## **CITY OF SANDUSKY BOARD OF ZONING APPEALS MEETING**

**May 18, 2017  
4:30 p.m.  
1ST FLOOR CONFERENCE ROOM, CITY BUILDING  
AGENDA**

# BOARD OF ZONING APPEALS REPORT

APPLICATION FOR VARIANCES TO ALLOW A  
COMMERCIAL STRUCTURE WITHIN A  
SPECIAL FLOOD HAZARD AREA

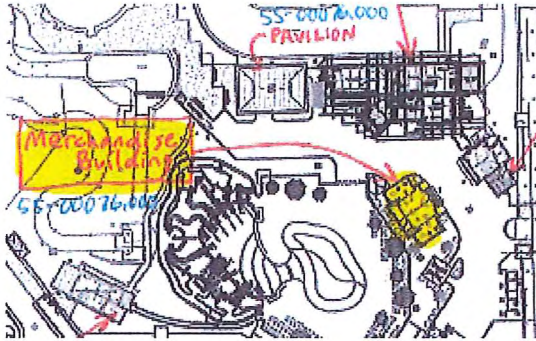
Cedar Point Park LLC has filed a variance application to the required Flood Protection Elevation at One Cedar Point Drive, for four new structures (2017) which proposed uses are merchandise, food, equipment and modification to the existing bathhouse. Due to the proposed and existing structures being above the 100 year floodplain elevation (577.2), but below the Flood Protection Elevation of 579.2, our Floodplain Ordinance (Chapter 1157) requires a variance be granted prior to building below the Flood Protection Elevation. In this case three structures are currently under construction and one existing structure is being modified.

Based on the provided information, and our review of the current elevations, we recommend that these four variances be approved.

## COLD REFRESH ADDITION TO TOFT'S BUILDING CEDAR POINT SHORES

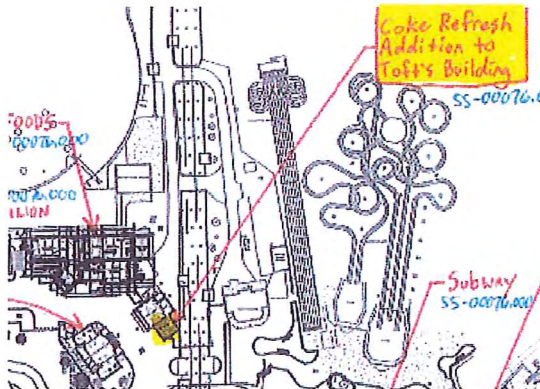
Variance Requested: Section 1157.04(d)(2)

1) To allow for a new structure (constructed 2017) that is above the Base flood elevation (floor elevation 578.5 - BFE 577.2) and below the flood protection elevation 579.2.

Staff has reviewed this request and based on the park not being open if there is a flooding event and the raising of the proposed floor is not feasible due to ADA slope accessibility. We do not anticipate any impact to the Base Flood Elevation based on this additional structure.

Division of Engineering Comments - We request that this item be granted a variance which would allow its current new use.

## CHILDREN'S POOL FILTER BUILDING ADDITION CEDAR POINT SHORES

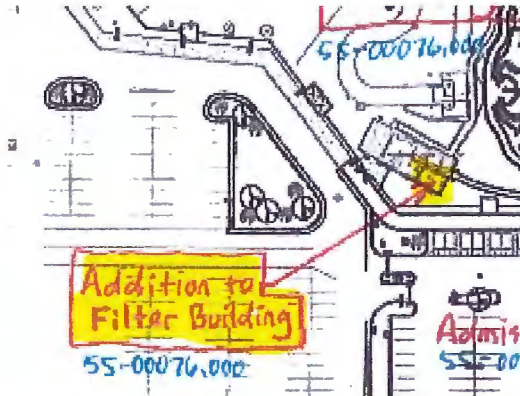
Variance Requested: Section 1157.04(d)(2)

1) To allow for a new structure (constructed 2017) that is above the Base flood elevation (floor elevation 578.75 - BFE 577.2) and below the flood protection elevation 579.2.

Staff has reviewed this request and based on the park not being open if there is a flooding event and the raising of the proposed floor is not feasible due to ADA slope accessibility. We do not anticipate any impact to the Base Flood Elevation based on this additional structure.

Division of Engineering Comments - We request that this item be granted a variance which would allow its current new use.

## BATH HOUSE BY HOTEL BREAKERS WING PARKING LOT CEDAR POINT SHORES

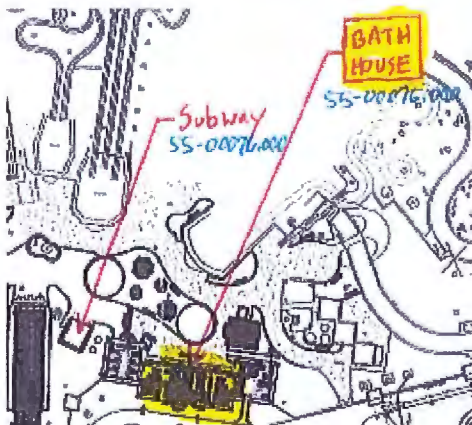
Variance Requested: Section 1157.04(d)(2)

1) To allow for interior modifications to the existing structure (modified 2017) that is above the Base flood elevation (floor elevation 578.77 - BFE 577.2) and below the flood protection elevation 579.2.

Staff has reviewed this request and based on the park not being open if there is a flooding event and the raising of the proposed floor is not feasible due to ADA slope accessibility. We do not anticipate any impact to the Base Flood Elevation based on this additional structure.

Division of Engineering Comments - We request that this item be granted a variance which would allow its current new use.
